**GENOA CHARTER TOWNSHIP  
ZONING BOARD OF APPEALS  
June 16, 2026  
6:30 P.M.  
AGENDA**

**TO:** Genoa Township Zoning Board of Appeals  
**FROM:** Carrie Aulette, Zoning Official  
**DATE:** May 29, 2026, 2026  
**RE:** ZBA 26-08

**File Number:** ZBA#26-08  
**Site Address:** 5167 Natura  
**Parcel Number:** 4711-31-200-017  
**Parcel Size:** 5.0 Acres  
**Applicant:** Raymond & Deanna Kutchey  
**Property Owner:** Raymond & Deanna Kutchey  
**Information Submitted:** Application, site plan, conceptual drawings  
**Request:** Dimensional Variance  
**Project Description:** Applicant is requesting a variance to build an accessory building  
**Zoning and Existing Use:** CE (Country Estates)

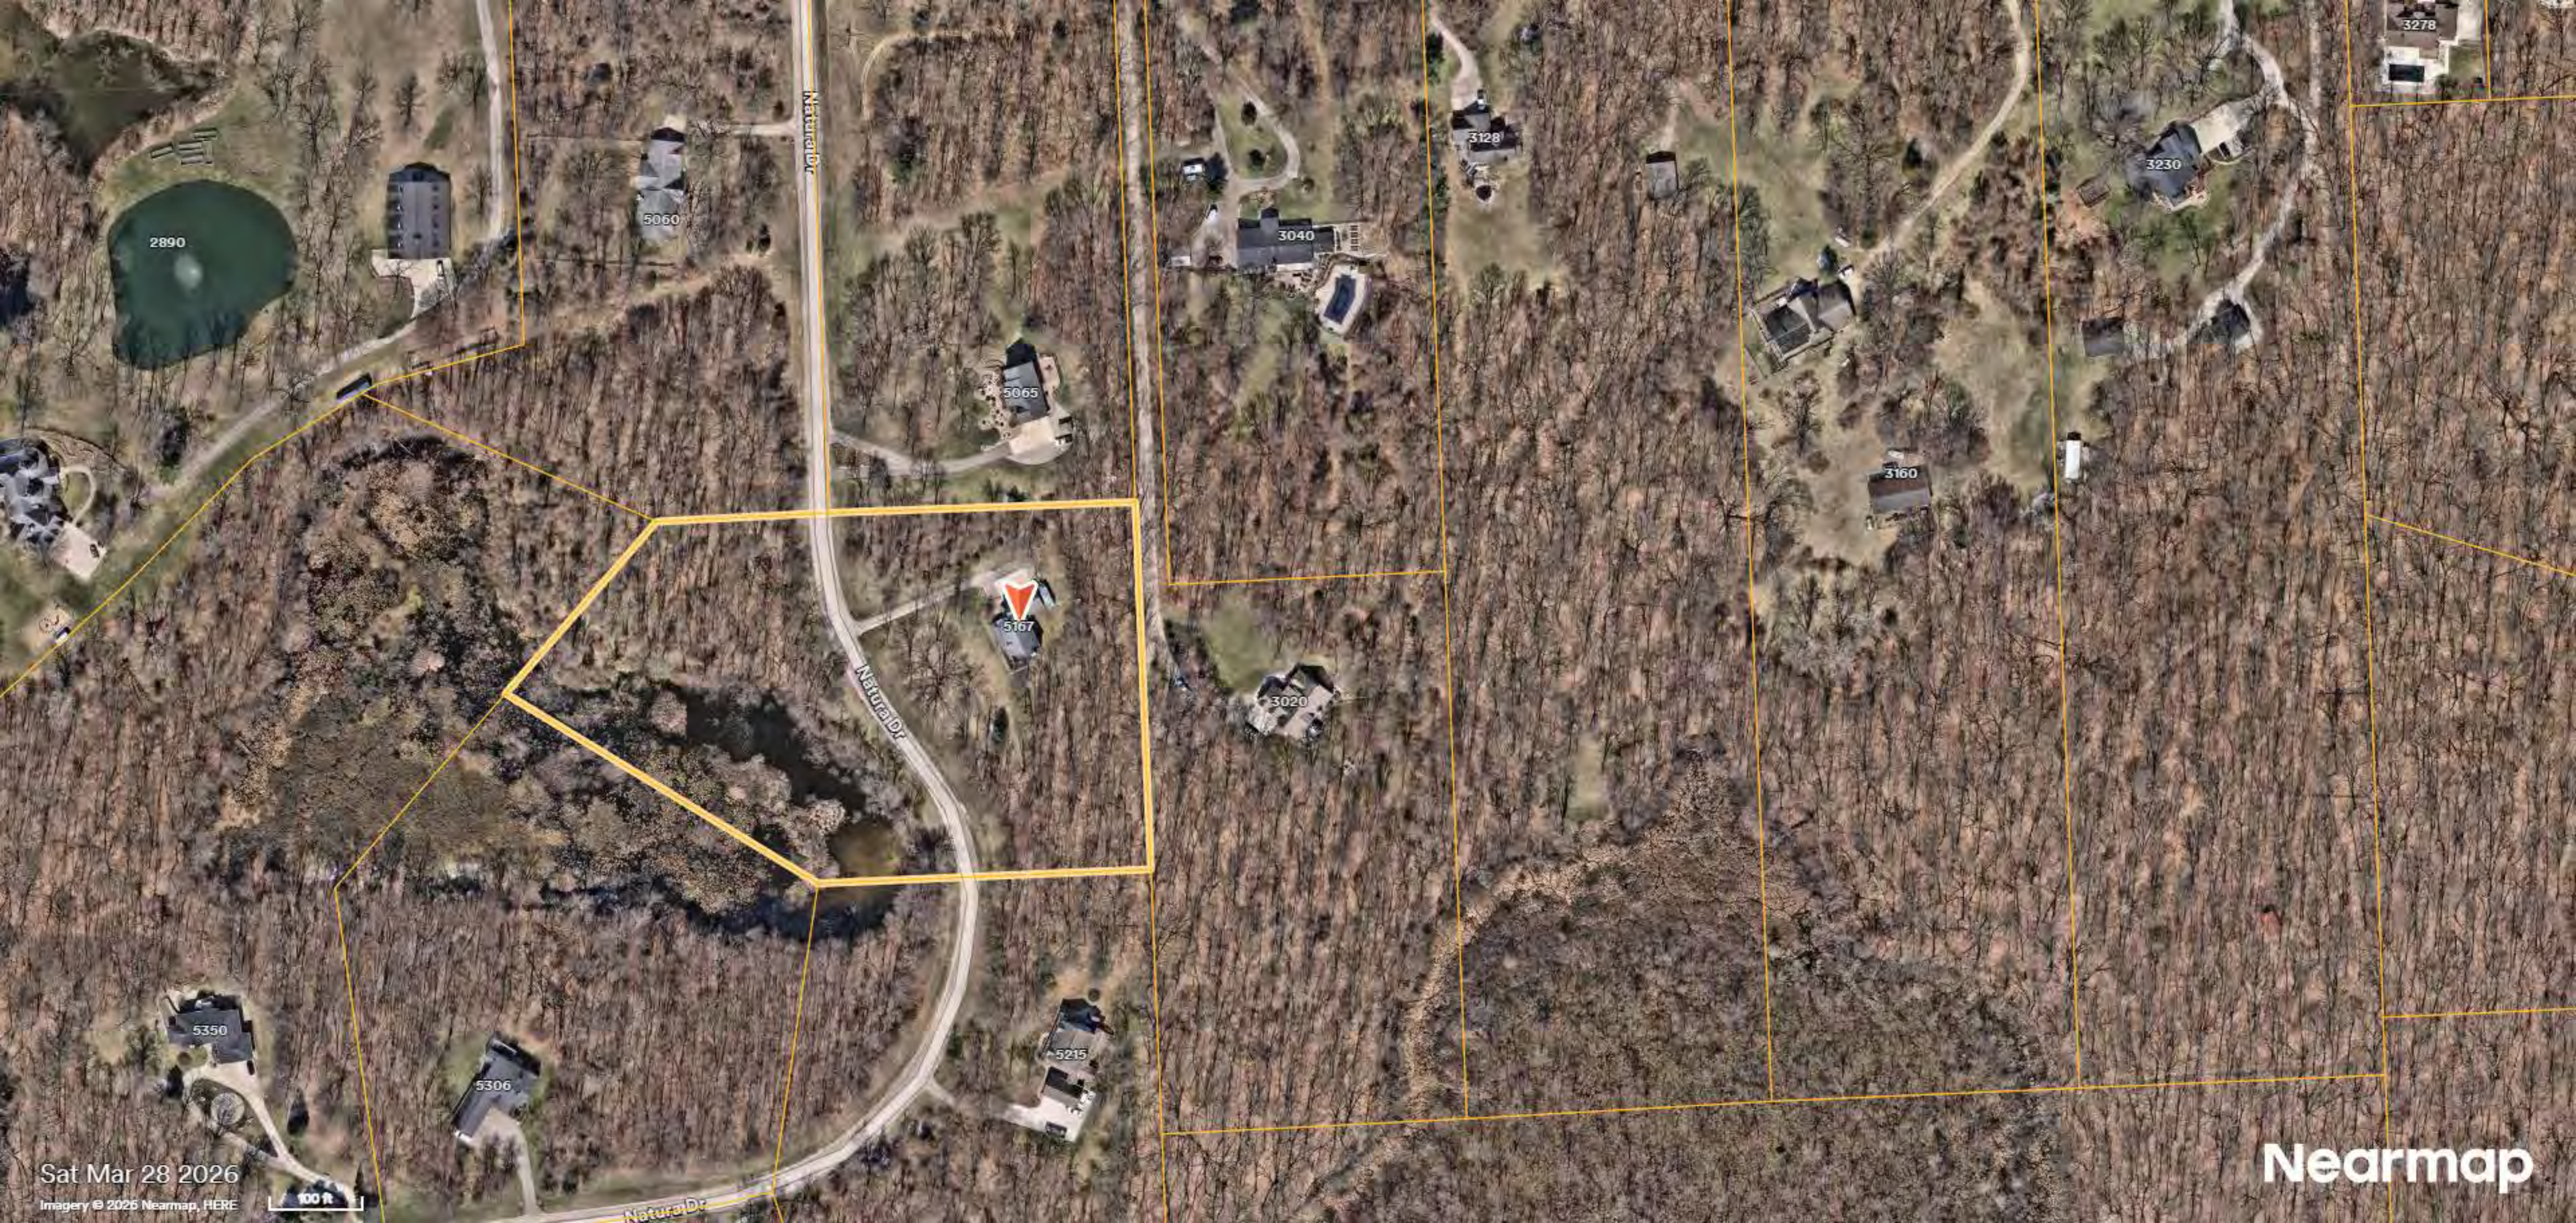
**Summary:** The applicant is requesting a variance from **Article 3.04 Dimensional Standards**. Applicant is proposing to build a detached garage and is asking for a side and rear yard setback variance.

**Minimum Side Yard Setback** 40'

**Requested Side Yard Setback** 32'

**Variance Amount** 8'

**Minimum Rear Setback** 60'

**Requested Rear Setback** 44.9

**Variance Amount** 15.1'

- (a) Practical Difficulty/Substantial Justice** – Strict application of the ordinance would prevent the applicant from reasonably constructing the accessory building on the property. Unlike other properties in the area, a substantial amount of the parcel is wetlands and is broken up by the drive. The applicant has worked closely with staff to ensure the request represents the minimum relief necessary to allow reasonable use of the property. If approved, it will not alter the character of the neighborhood. The need for the request is not self-created.

- (b) Extraordinary Circumstances** – The subject property is a 5 acre parcel zoned Country Estates. Due to the unique configuration of the lot with the private drive running through the center of it, sloped terrain behind the home and a wetland area, strict compliance with the required setback standards limits reasonable placement of any accessory structure.

- (c) Public Safety and Welfare** –Staff does not believe the proposed detached garage would have an impact on the public safety and welfare of Genoa Township residents.

- (d) Impact on Surrounding Neighborhood** – Staff does not believe the proposed detached garage will have an impact on the surrounding neighborhood.

1. The structure must be guttered with downspouts.

DETAIL A: AREA OF PROPOSED IMPROVEMENTS WITHIN 25' WETLAND SETBACK  
 SOFT: 1073.17±  
 ACRES: 0.025±  
 SCALE 1"=100'

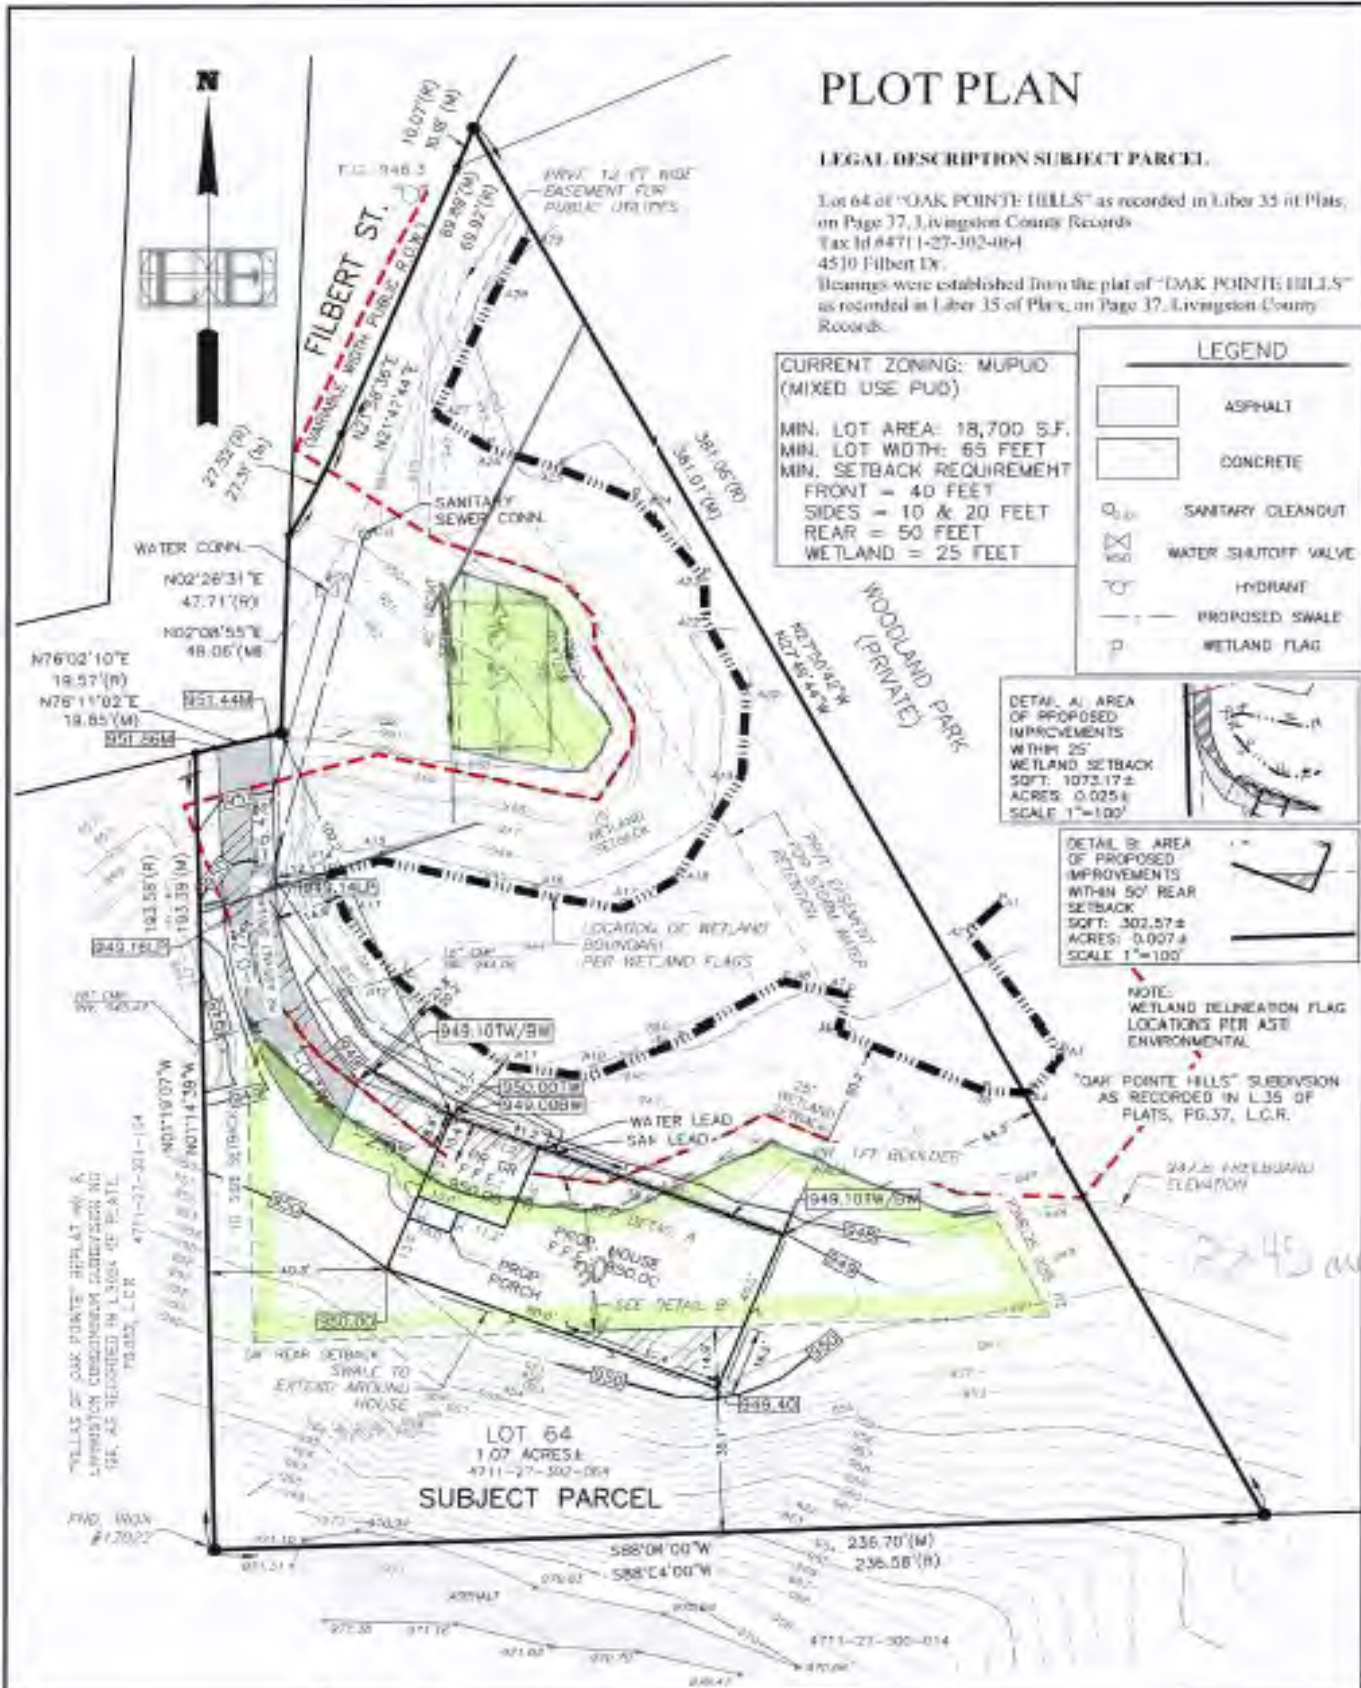
- (d)** The applicant has not provided sufficient evidence that alternative building locations, site configurations, or dwelling designs have been explored to reduce the need for the requested variances. After Staff review of the Plot Plan it is thought that there may be other areas on the parcel a home could be placed without encroaching into the wetland buffer or possibly encroaching less than what is being proposed. That highlighted plot has been attached to this report. The Zoning Board may wish to consider whether modifications to the proposed house footprint, building orientation, placement on the lot, or overall site design could achieve the applicant's objectives while reducing encroachments into required setback areas and lessening the degree of variance relief sought.

**SHEET 8 OF 8**

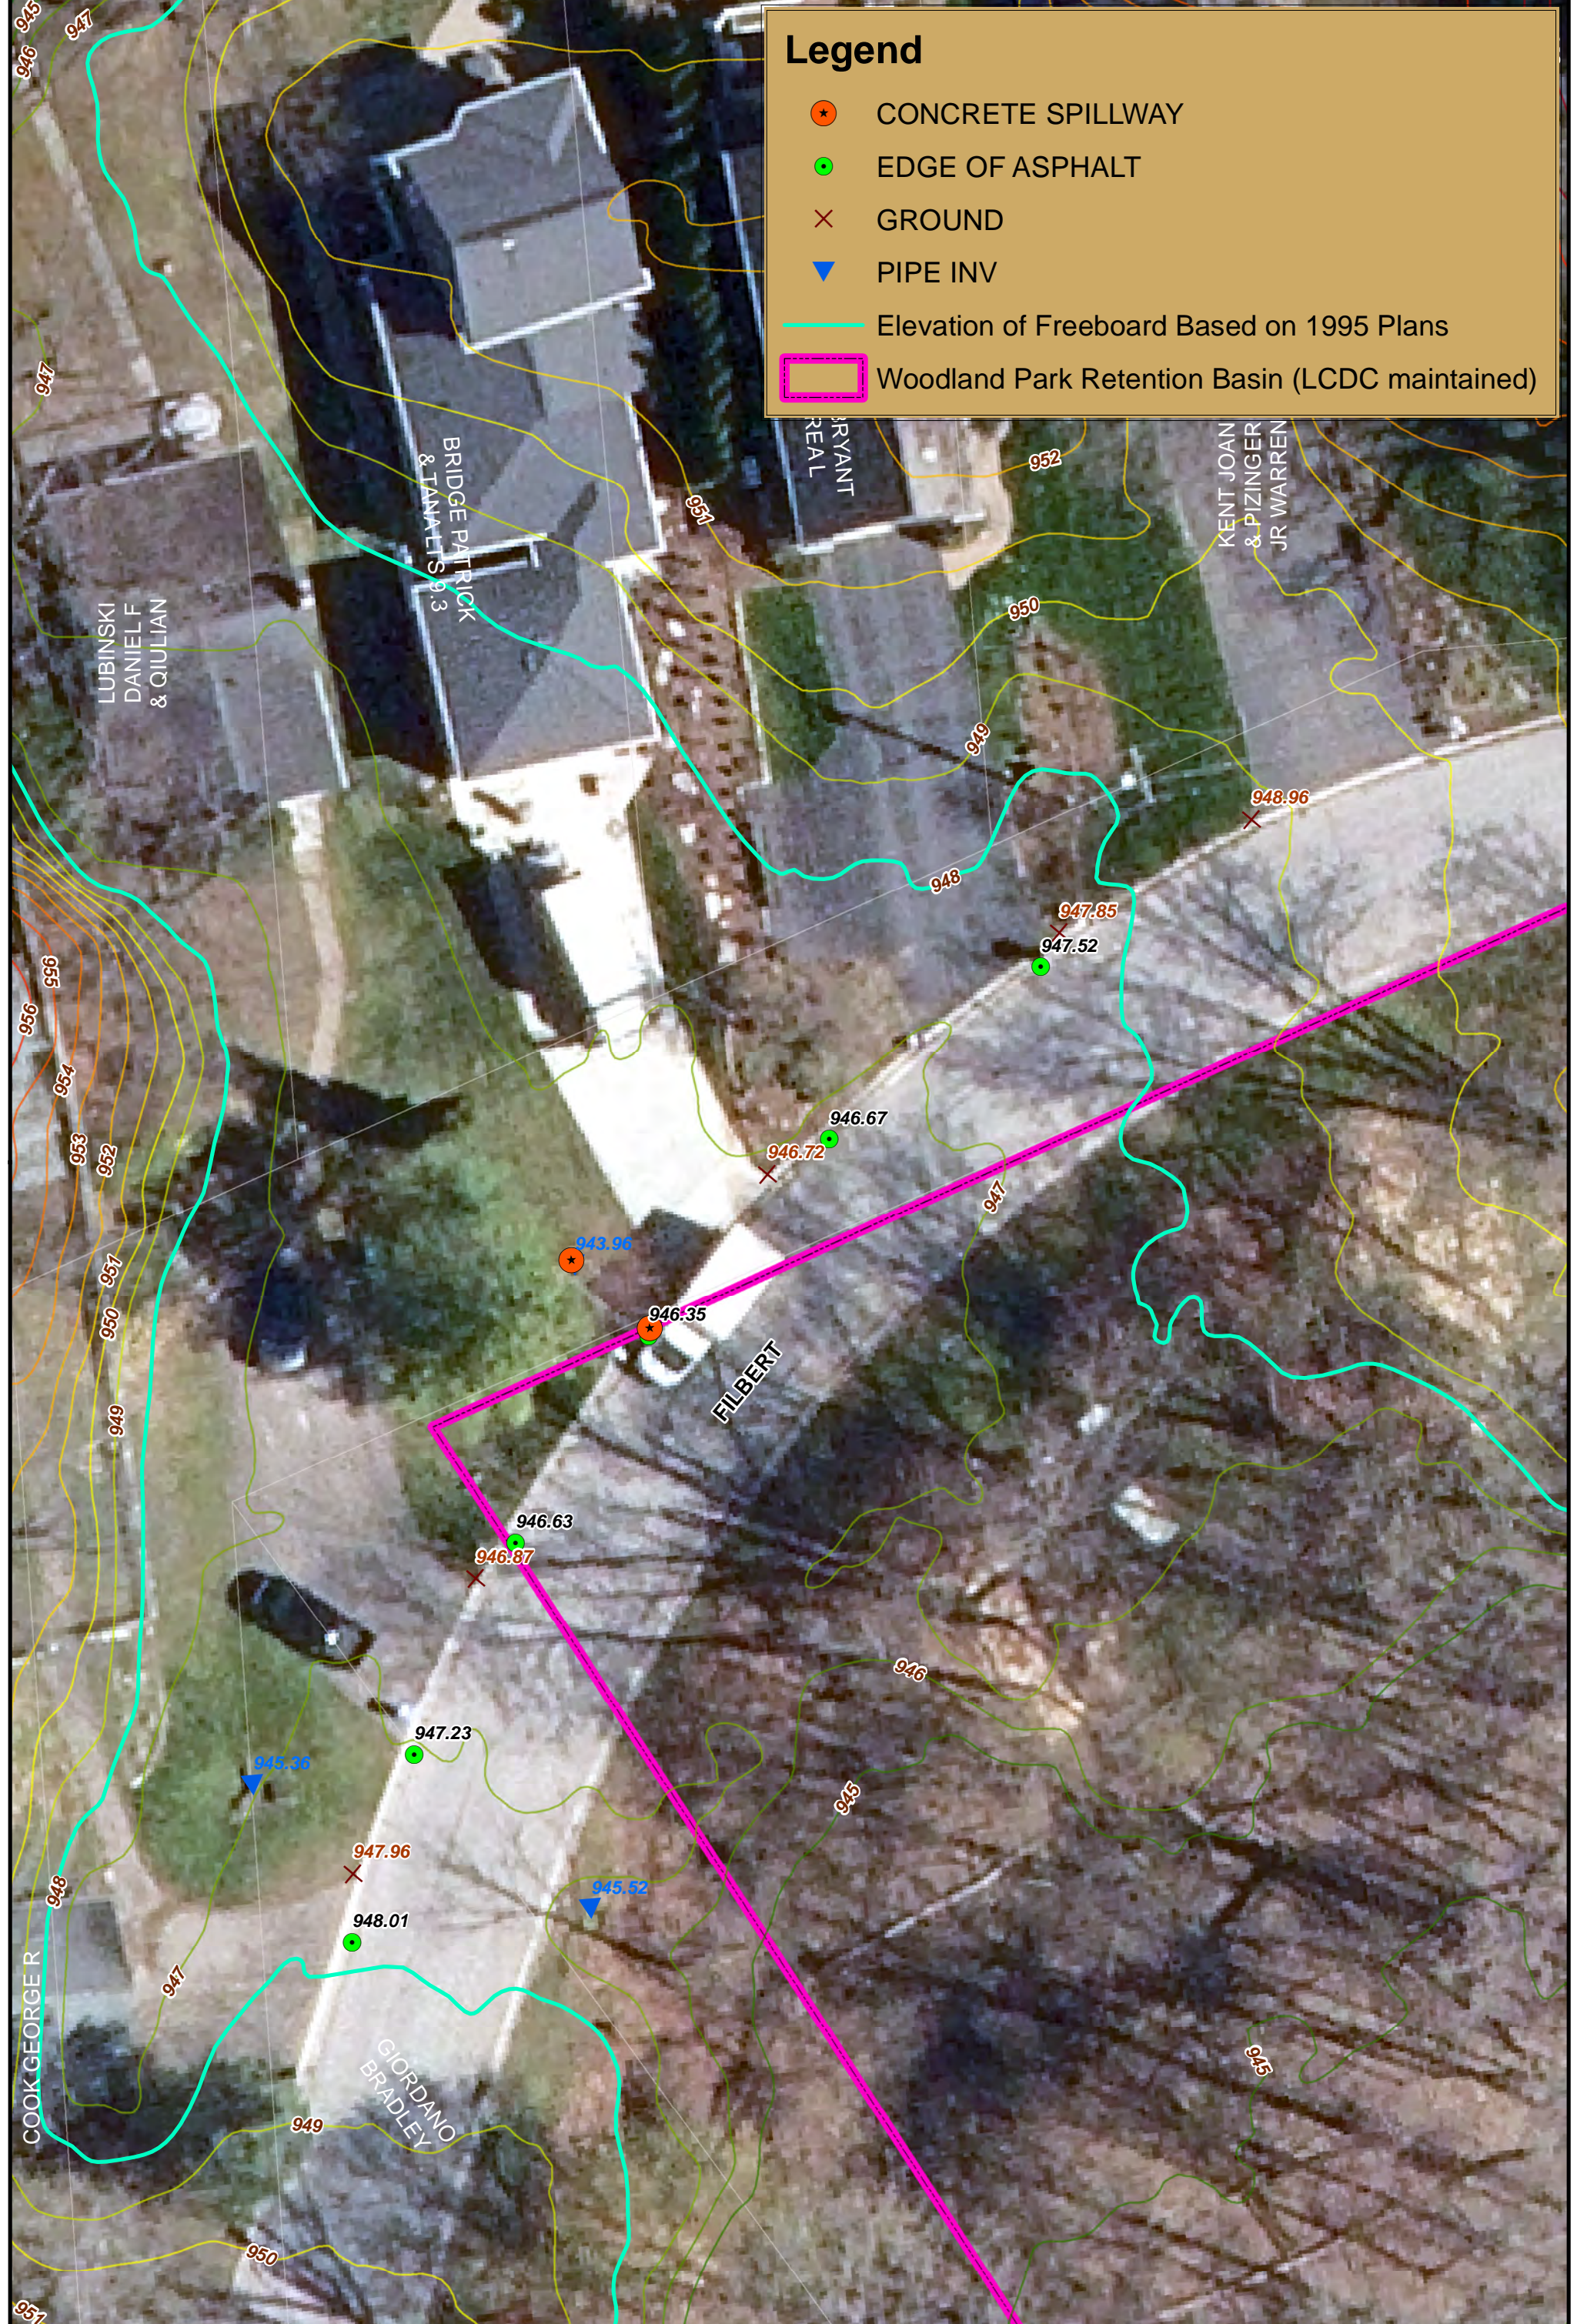
4. Due to proximity of several homes to the basin freeboard elevations on the plans, provisions for emergency pumping during a power outage should be made by the homeowners association. These provisions should take into account the limited ability of the downstream system to take flows, as shown on sheet 8.
